This Service Information bulletin supersedes SI B61 34 14 dated December 2014.

Service Action: Replace Neck Warmer Control Unit

F33 (4 Series Convertible)

F83 (M4 Convertible)

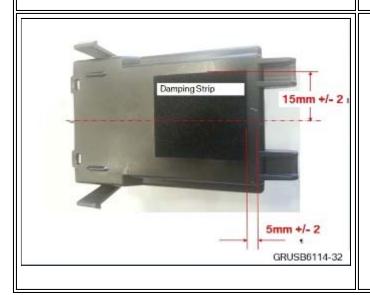
- The control unit is located under the rear seat bottom, as shown in the photo, and is clipped in place.
- 2. Unplug the two electrical connectors and remove the neck

warmer control unit.

- 3. Prior to installing the new control unit, install a damping strip (self-sticking) onto the back side of the control unit in the position shown.
- 4. Plug in the electrical connectors and install the new control unit.

Replace the neck warmer control unit and install the damping strip.
